CERTIFICATE OF APPROPRIATENESS**Application Date:** July 11, 2025**Applicant:** Michael Zertuche, owner**Property:** 309 Bayland, Tracts 7 & 8, Block 6, Woodland Heights Neighborhood Subdivision.

Significance: Contributing Craftsman Bungalow style residence, constructed circa 1920, located in the Woodland Heights Historic District.**Proposal:** Alteration – Addition

Recommendation: Approval with conditions: Second floor addition is to be pushed back 5ft or be within 25%. Whichever is greater. AND inset 2ft on second floor west and east elevations to maintain original corners of existing house.

SITE PLAN

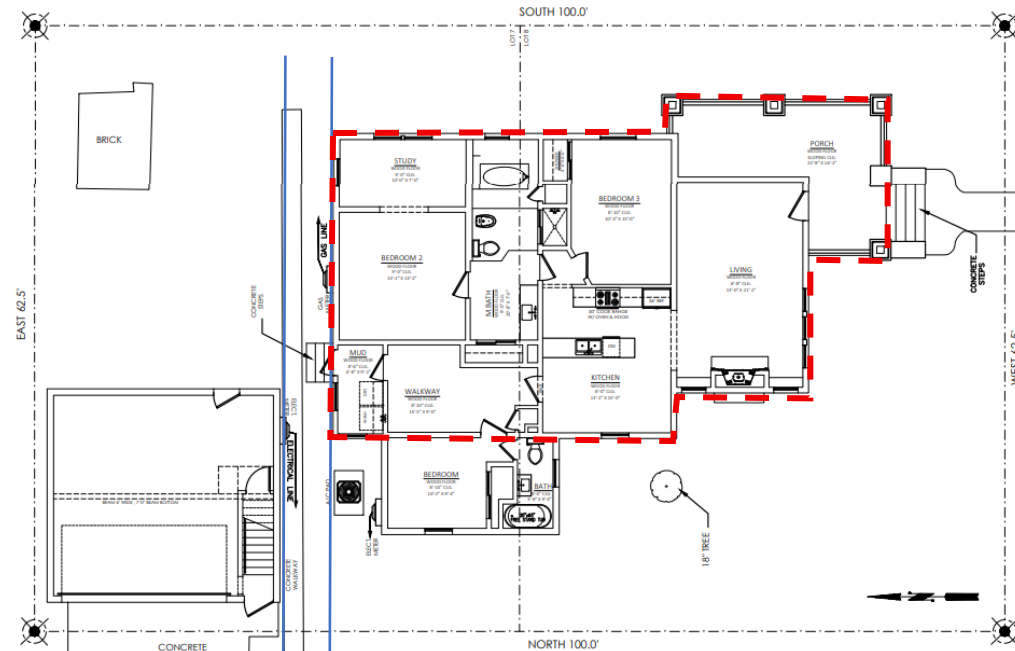
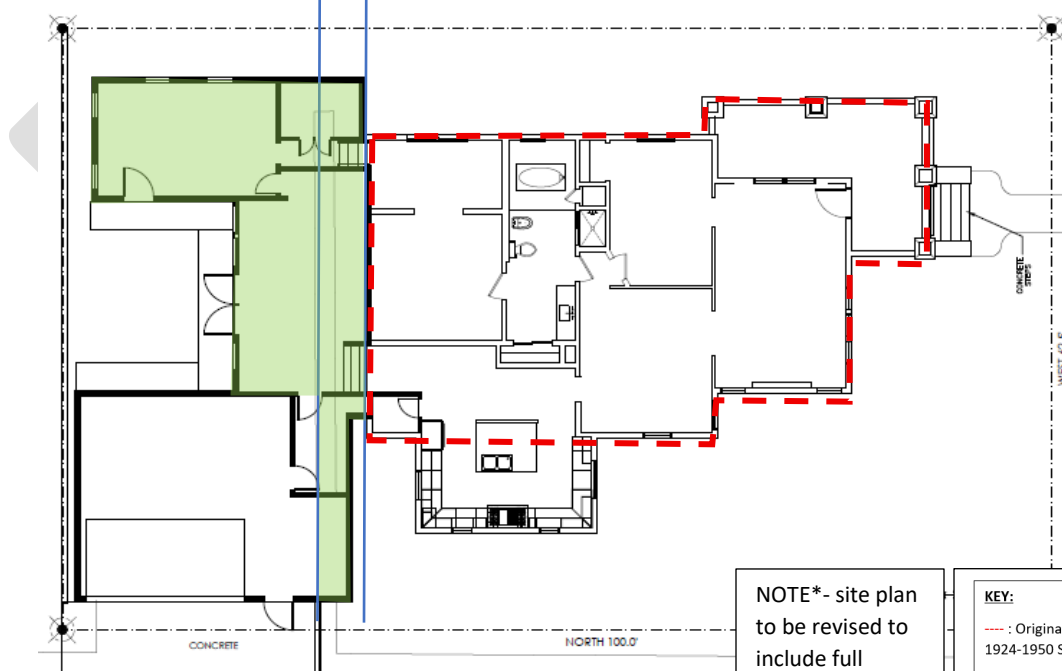
NOTE*- site plan
to be revised to
include full
dimensions.

ROOFPLAN

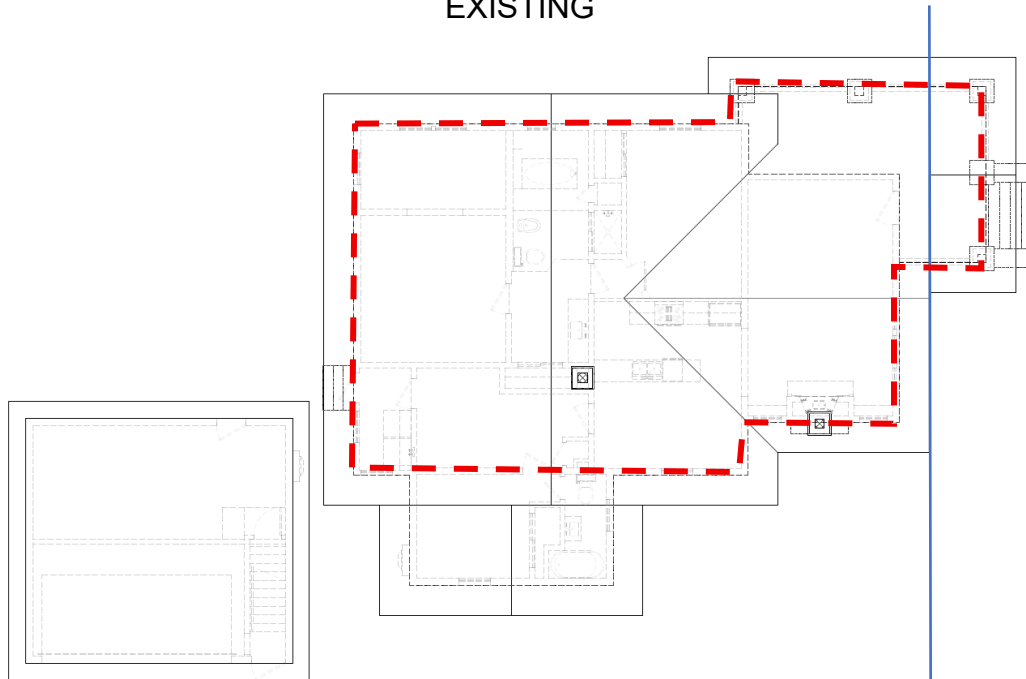
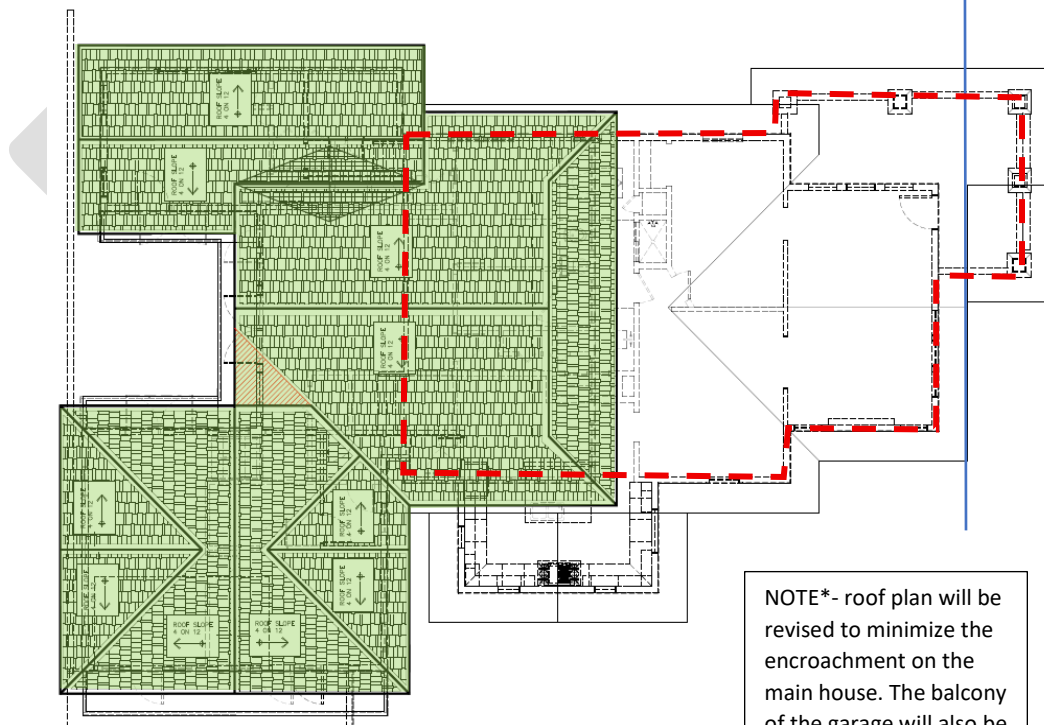
NOTE*- roof plan will be revised to minimize the encroachment on the main house. The balcony of the garage will also be revised to reflect current elevation drawings.

SECOND FLOORPLAN

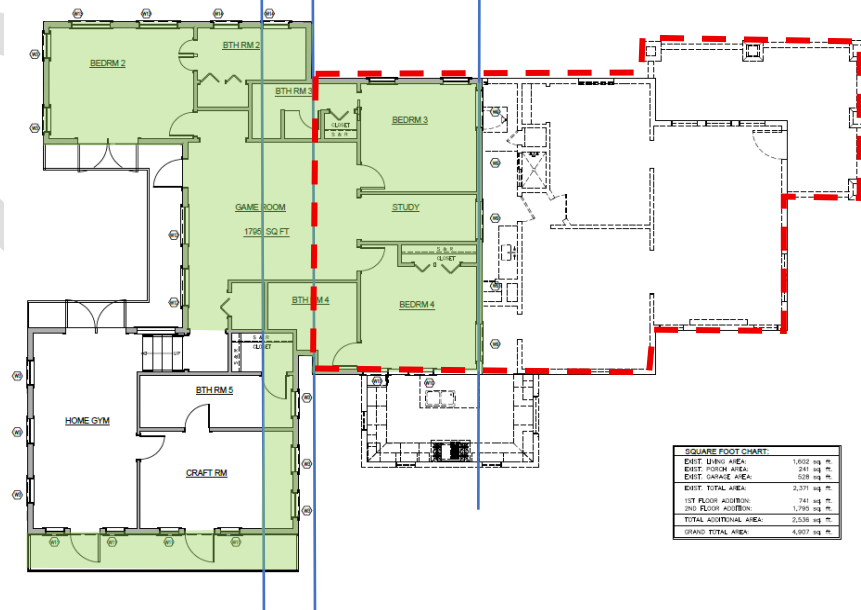
NOTE*- floorplan to be revised to include more dimensions. The addition will be brought in to not be so far forward on the main house, and the sides of the addition will be inset. The balcony of the garage will also be revised to reflect current elevation drawings.

EAST (RIGHT) ELEVATION

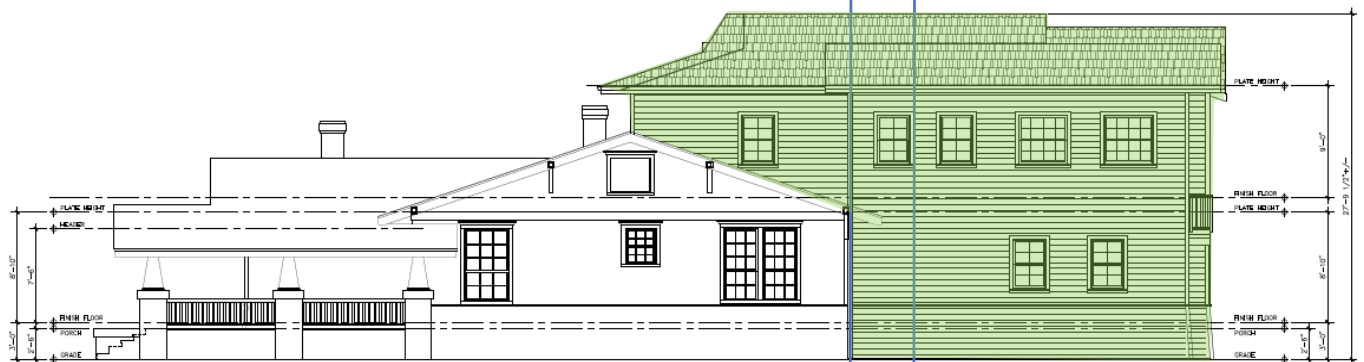
NOTE*- elevation will be revised to depict simplified lite patterns on the addition, as well as reduce the plate height and minimize the encroachment on the main house.
